United States Patent and Trademark Office

DETAILED ACTION

The amendment filed on February 15, 2006 has been entered. Claims 1-6, 10-15 and 19-26 are pending. The final Office action mailed December 15, 2005 is withdrawn due to the rejection of dependent claims 21-24.

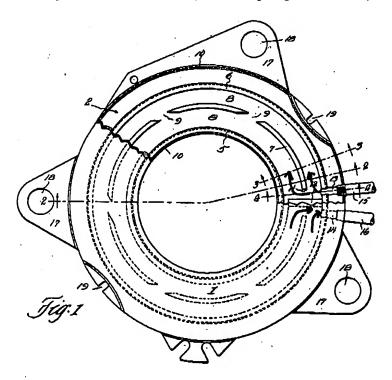
Claims 1 and 10 are rejected under 35 U.S.C. 102(b) as being clearly anticipated by Vandergrift. Vandergrift (Figure 2-5) discloses a first member 1 with semi-circular channel walls 3, 4 interlaced with a second member 2 with semi-circular channel walls 5, 6, 7 to provide two fluid flow paths having different directions (marked-up Figure 1 below).

The first fluid flow path from fluid inlet 13 turns immediately into the outer channel 8 proceeding until it turns immediately into the fluid outlet 14. The second fluid path extends radially inward or straight from the fluid inlet 13 and turn into the inner channel 8 beyond the semi-circular wall 7 proceeding until it turns immediately toward the fluid outlet beyond the semi-circular wall 7.
